**PLANNING APPROVAL &
PLANNED UNIT DEVELOPMENT
STAFF REPORT**

Date: April 21, 2005

<u>NAME</u>	Port City Church of Christ
<u>LOCATION</u>	2901 Hillcrest Road (East side of Hillcrest Road, 125 feet \pm south of Medearis Court)
<u>CITY COUNCIL DISTRICT</u>	District 6
<u>PRESENT ZONING</u>	R-1
<u>AREA OF PROPERTY</u>	4.71 acres \pm
<u>CONTEMPLATED USE</u>	Parking lot expansion at an existing church.
<u>TIME SCHEDULE FOR DEVELOPMENT</u>	Immediate
<u>ENGINEERING COMMENTS</u>	Must comply with all stormwater and flood control ordinances. Any work performed in the right of way will require a right of way permit.
<u>TRAFFIC ENGINEERING COMMENTS</u>	Driveway number, size, location and design to be approved by Traffic Engineering and conform to AASHTO standards.
<u>URBAN FORESTRY COMMENTS</u>	Property to be developed in compliance with state and local laws that pertain to tree preservation and protection on both city and private properties (State Act 61-929 and City Code Chapters 57 and 64). Preservation status is to be given to the 48" Live Oak Tree located on the South side of Lot and 50" Live Oak Tree located in the South East corner of Lot. Any work on or under these trees is to be perm

SITE PLAN

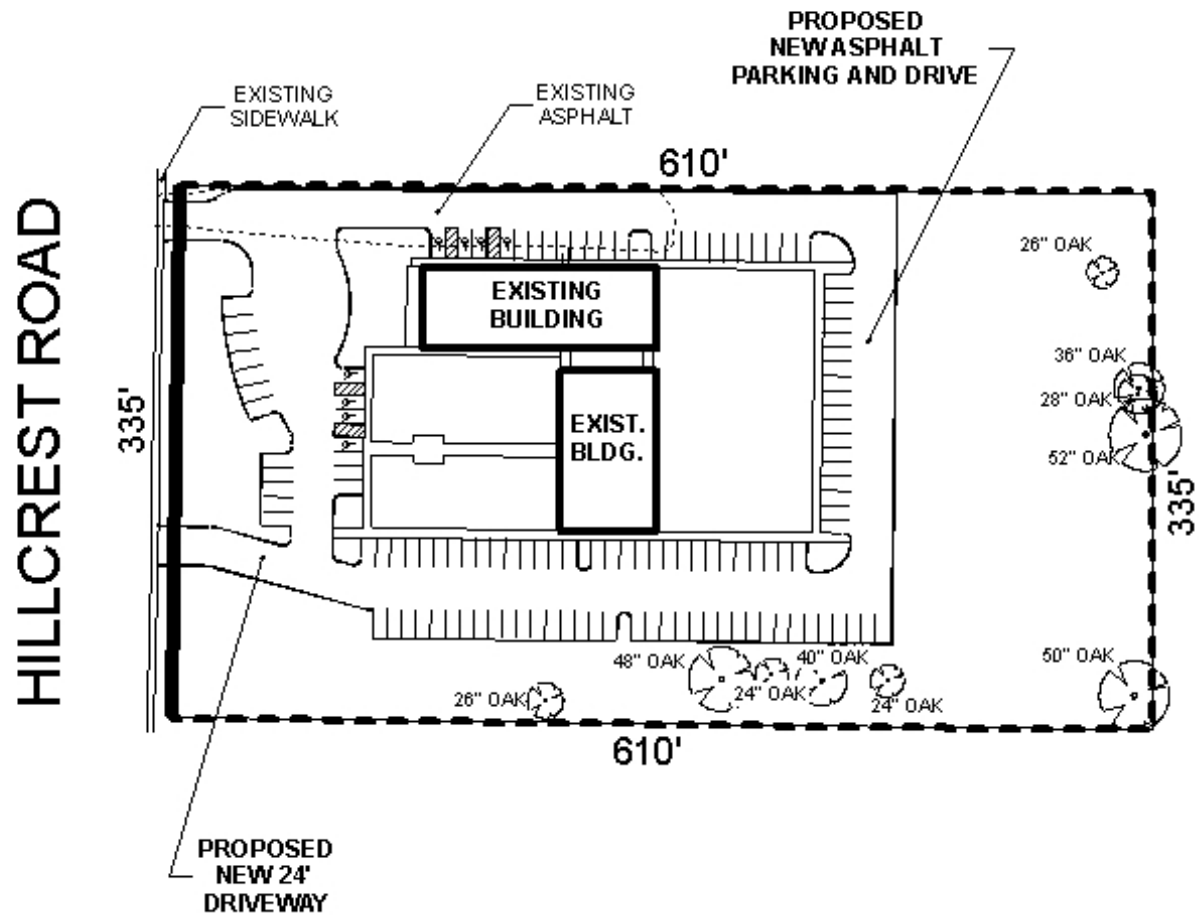
In order for the proposed parking area to fully comply with Section VI.A. of the Zoning Ordinance, the following requirements will have to be met: 1) provision of wheel stops for those parking spaces lacking a curb to stop forward movement of a parked vehicle; 2) provision of lighting for the parking area, that does not shine onto residential properties (use of "full cut-off" fixtures); 3) full compliance with the screening and landscaping requirements for parking areas

in Section VI.A.3.i.; and 4) limitation of the size of vehicles using the parking area to vehicles weighing 8,000 pounds or less.

The site contains approximately 36 trees, 12 inches DBH and larger, that the applicant intends to count towards the landscaping and tree ordinance requirements. Therefore the applicant will have to ensure that the trees are protected per the standards contained in Section IV.E.4.c. of the Zoning Ordinance. Existing heritage trees less than 12 inches DBH and at least 3 inches DBH, that the applicant intends to use to fulfill the landscaping and tree ordinance requirements, must also be protected.

The site fronts Hillcrest Road, a major street, which has an existing right-of-way width of 100 feet, and therefore complies with the Major Street Plan. Because Hillcrest is a major street, access management is a concern. The church has one existing curb cut which permits northbound and southbound access to/from Hillcrest Road, and is proposing one new curb cut that will provide limited access to Hillcrest (due to a median on Hillcrest that will prevent southbound access to /from the site). It is recommended that the church be permitted the proposed second access point, but that no additional curb cuts be permitted, and that the median remain intact in order to reduce turning movements to/from southbound Hillcrest Road.

The site plan does not indicate the location of a stormwater detention basin, which will be required for the site. A stormwater detention basin, sized to meet the requirements of the City's Storm Water Drainage Ordinance, must be indicated on the site plan. It should also be noted that neighbors adjacent to the church have contacted Urban Development Department staff to express concern regarding the potential for increased stormwater run-off from the site due to the proposed increase in the paved parking area.

Finally, there is no indication on the site plan as to the proposed location of any dumpster or other waste storage facility. If the applicant utilizes a dumpster, the location of the storage area for the dumpster must be indicated on the site plan, and the location and required screening must comply Section IV.D.9. of the Zoning Ordinance, as well as with all other applicable regulations.

Planning Approval: based on the preceding, it is recommended that the proposed parking lot expansion be approved, subject to the following conditions: 1) placement of a note on the site plan stating that Planning Approval and PUD approval are site plan specific, and that modifications or additions will require new Planning Approval and PUD applications; 2) provision of landscaping and tree planting in accordance with the quantities and ratios set forth in Section IV.E.3. (Minimum Landscape Requirements) of the Zoning Ordinance, as amended, and comply with Sections IV.E.4. and IV.E.5. of the

Ordinance; 3) full compliance with Section VI.A. (Off-Street Parking Requirements) of the Zoning Ordinance, as amended; 4) placement of a note on the site plan stating that the lot is limited to a maximum of two curb-cuts, one existing and one new, with no breach of the existing median on Hillcrest Road, with the size and location of curb cuts to be approved by Traffic Engineering; 5) full compliance with the Storm Water Drainage Ordinance, including the provision of a storm water detention basin to be indicated on the final site plan; 6) placement of a note on the final site plan stating that *“preservation status is to be given to the 48” Live Oak Tree located on the South side of Lot and the 50” Live Oak Tree located in the South East corner of Lot. Any work on or under these trees is to be permitted and coordinated with Urban Forestry; removal to be permitted only in the case of disease or impending danger.”*; and 7) full compliance with all other applicable municipal codes and ordinances.
